# Parking Statement

**Condition 6,7and 9 of  
21/05551/FULL1 (appeal APP/G5180/W/22/3293737)**

**Conversion and extension of existing dwelling  
into 5 self-contained flats**

**20 Manor Road**

Extract of parking layout shown on D100 revB

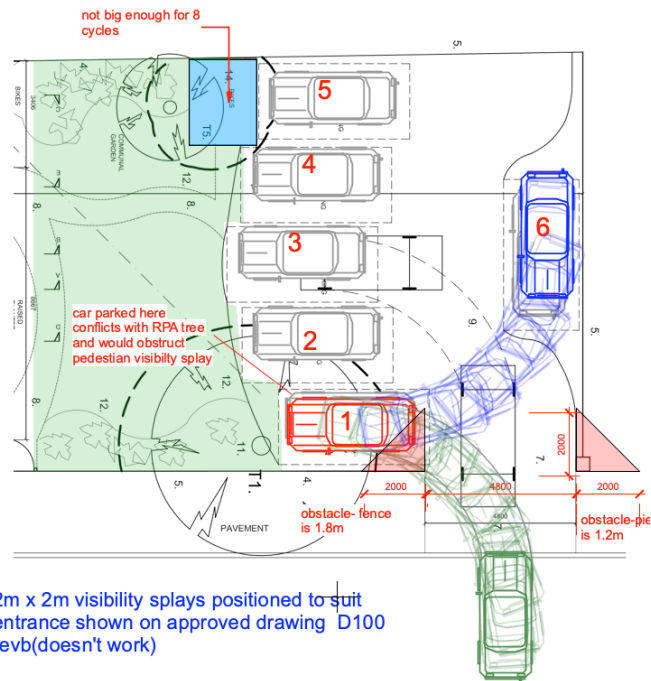
According to guidance in the Manual for Streets, 2m x 2m pedestrian visibility splays are required at the entrance with no obstacles /planting higher than 0.6m. Drawing D1001 rev B shows the proposal using the existing driveway entrance (for single car use). There is currently a 1.2m brick pier on the neighbouring boundary to the right-hand side of the entrance and a 1.8m high fence on the left-hand side, both of which obstruct visibility. To keep the existing entrance as shown is dangerous and would not comply.

Left hand side.  
Fence can be lower but can't have parking space as above 600mm

Righthand side.  
1.2m high pier to neighbouring boundary - can't be moved

2m x 2m visibility splays positioned to suit entrance shown on approved drawing D100 revb(doesn't work)

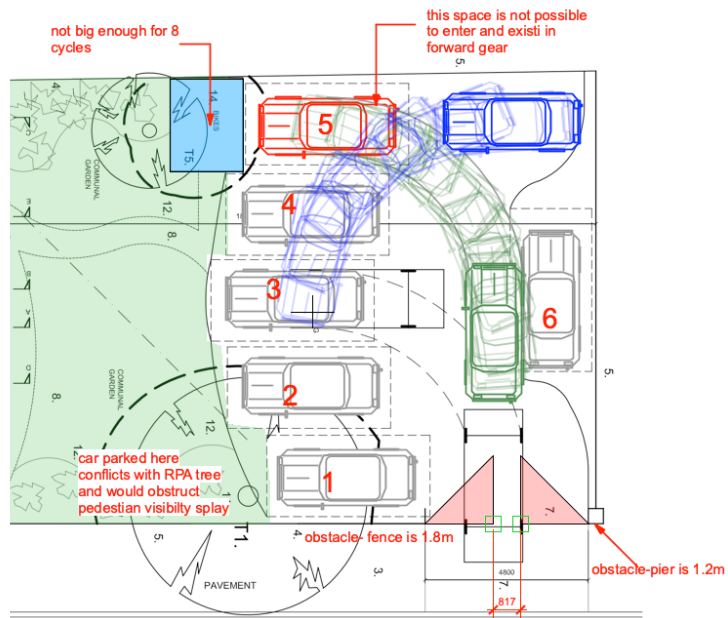
Furthermore, with the parking arrangement shown, it is difficult to enter & exit in forward gear as there is no room to turn out of most spaces. One of the spaces impacts the tree T1 RPA and the entrance visibility splay.

Cannot drive in and out of spaces 1,2,4,5 & 6 in forward gear. Example shown :reversing out of space 1 collides with car in space 6

2m x 2m visibility splays positioned to avoid current obstacles (doesn't work - entrance not wide enough)

Cannot drive in and out of spaces 1,2,4,5 & 6 in forward gear. Example shown :driving into space 5 is tight and reversing out of space 5 it is impossible to turn without colliding with space 4 & 3

Therefore, in order to satisfy Condition 6, we have needed to revise the position of the site entrance. To ensure compliance, the new layout has been prepared in collaboration with Tridax Ltd, who are a specialist Highways Consultant.

The entrance has been shifted down slightly to ensure 2mx2m clear pedestrian visibility as well as a 2.4m x 25m vehicular sightline – (Manual for Streets – 7.7 and table 7.1). Traffic speed would be expected to be very low along this part of Bevington Road due to the parking each side and proximity of the junction with Manor Road.

Vehicle movement tracking showed the original parking layout did not work as it was not possible to enter and exist in forward gear. Vehicle movement tracking as been applied to the new layout and this shows compliance – the vehicles are able to enter & exit in forward gear.
